WASHINGTON STATE
DEPARTMENT OF TRANSPORTATION

SEQUENTIAL KINKING TERMINAL (SKT-350) ASSEMBLY 2 FOUNDATION TUBE OPTION

DRAWN/REVISED BY: LS/DS DATE REVISED: 3/3/98 DWG NO.: SKT-2US 1 1 PG: 01 OF: 01

ROAD SYSTEMS INC.
BIG SPRING, TX
(915)-263-2435 or (815)-464-5917

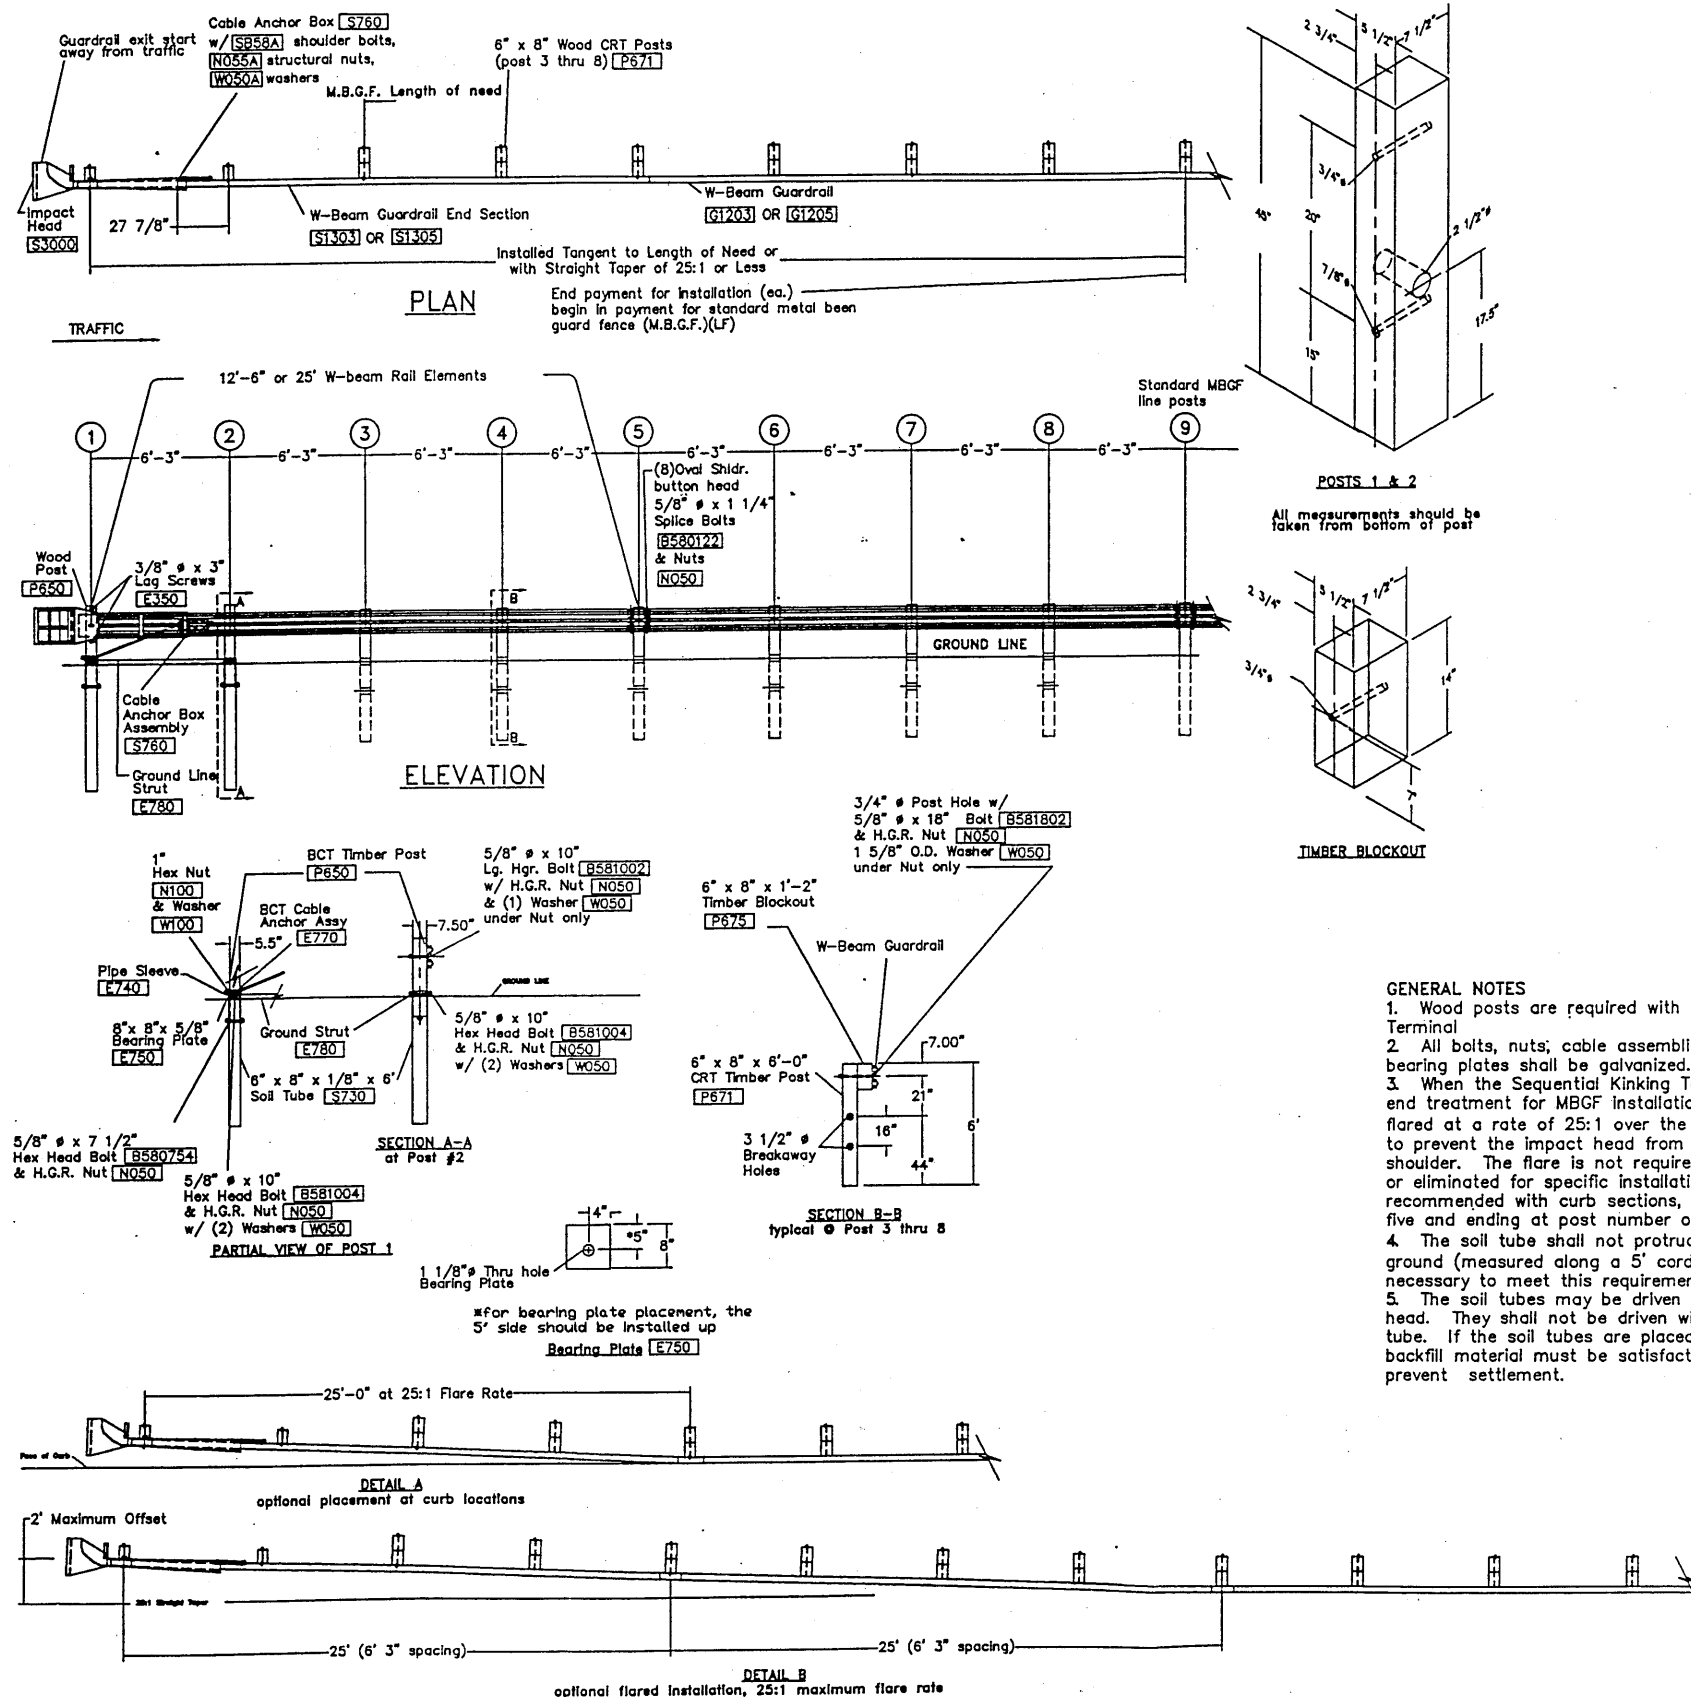
Approved

Approved with revision

Rejected

BY: *Paul B. B.*

DATE: 11/4/98
